Talbot Mackenzie & Associates

Re: Tree Impact Mitigation Report – 1303 Fairfield Road

Assignment: Review the plans provided of the mixed use building that is proposed on the 1303 Fairfield Road property and provide recommendations to mitigate impacts to trees located on adjacent properties and trees located on the municipal boulevard.

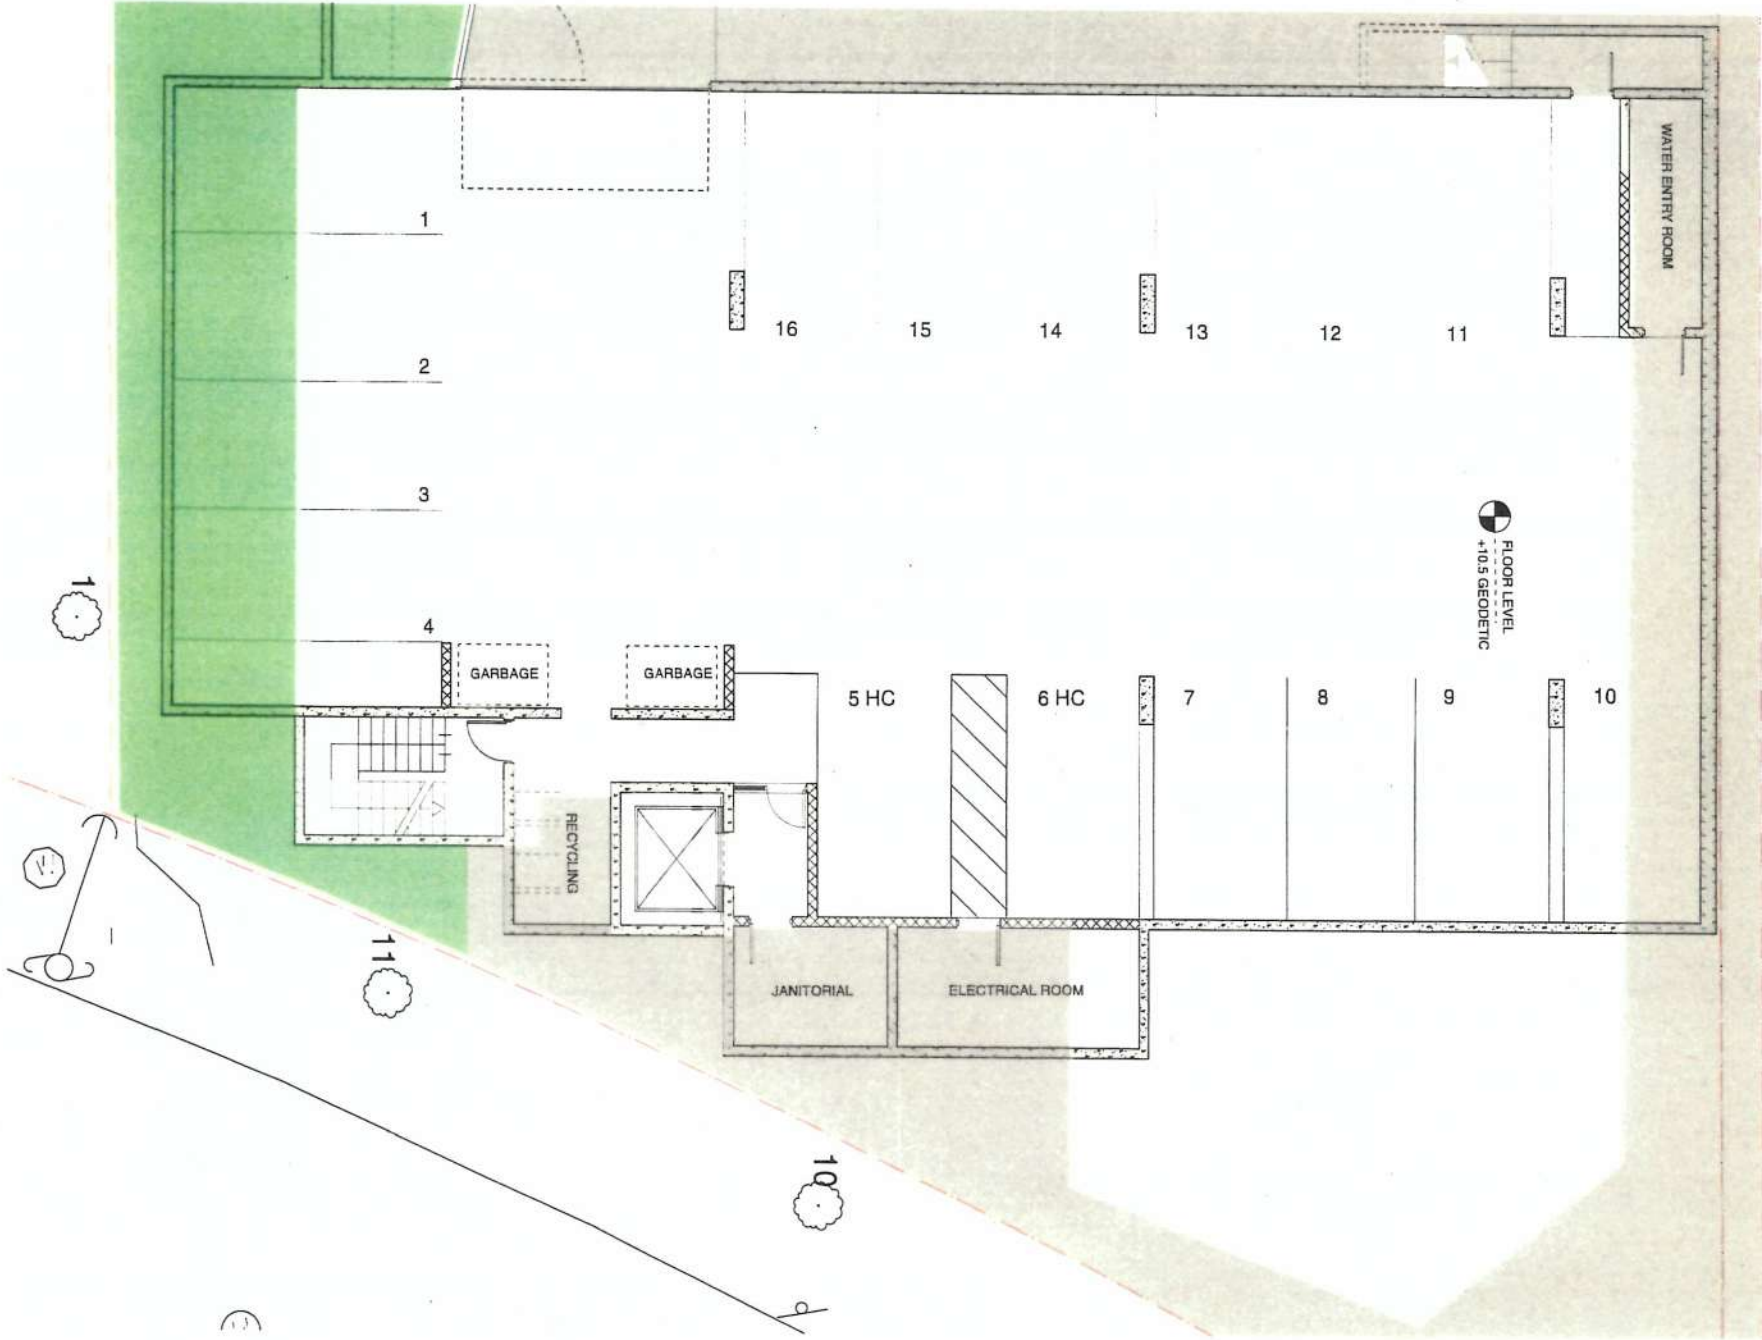
- According to the plans provided the footprint of the underground parking area encroaches within the critical root zone of the 40/55cm d.b.h. Big Leaf maple located on the neighboring property at 1311 Fairfield Road. The existing building on the subject property is located where it may be obstructing root growth toward the footprint of the proposed underground parking area. While it may be possible to retain this tree if impacts can be mitigated, this tree has outgrown its growing location, has existing structural defects, and in our opinion, it would be most prudent to offer a replacement tree, planted in a more suitable growing location, rather than attempting to this tree. If this tree is to be retained, we recommend the following course of action:

- According to the plans provided, the footprint of the proposed entrance/exit ramp to the underground parking area encroaches within the critical root zones of the 45cm d.b.h. laburnum located on the neighbouring property at 1311 Fairfield Road, and the 50cm d.b.h. Rhobinia located on the neighbouring property at 339 Moss Street. If these trees are to be retained, we recommend the following course of action:

- According to the plans provided, the location of the proposed entrance/exit ramp will necessitate the removal of the 56cm d.b.h. flowering cherry(no tag 7) located on the municipal boulevard.

- According to the plans provided, excavation will be required for the building foundation/underground parking walls, within the critical root zone of the 69cm d.b.h. flowering cherry(no tag 8) located on the municipal boulevard. This tree is in declining health, is infected with the *Ganoderma* wood decay pathogen. In our opinion, it would be most prudent to replace this tree with a young, healthy specimen.

- According to the plans provided, excavation for a retaining wall will be required within the critical root zone of the 34cm d.b.h. Flowering cherry(No tag 9) located on the municipal boulevard. At this time we have not seen plans that show grade requirements or construction details of this retaining wall; however, we anticipate that root pruning will be required. Once we see more detailed plans of this retaining wall we can provide recommendations to be used to mitigate impacts during construction, if this tree is to be retained.

- Excavation to remove the portion of the foundation of the existing building that encroaches within the critical root zone of this tree be removed under arborist supervision.

- Depending on the soil conditions encountered, shoring may be required to stabilize the embankment, within the critical root zone of this tree, as opposed to cutslope excavation.

- Space will likely be limited to form the walls of the underground parking area and install perimeter drains and waterproofing, and if it is found that there isn't sufficient working room, between the tree and the building foundation, this tree will likely require removal.

- The project arborist supervise excavation for the portion of the footprint of the proposed underground entrance/exit ramp that encroaches within the critical root zones of these trees. If significant structural roots are encountered during excavation that cannot be retained, we may recommend that trees be removed.

- Depending on the soil conditions encountered, shoring may be required to stabilize the embankment, within the critical root zone of this tree, as opposed to cut slope excavation.

- Exploratory excavation could be performed to determine the extent of root structures within the area of proposed excavation, once the footprint is laid out onsite.
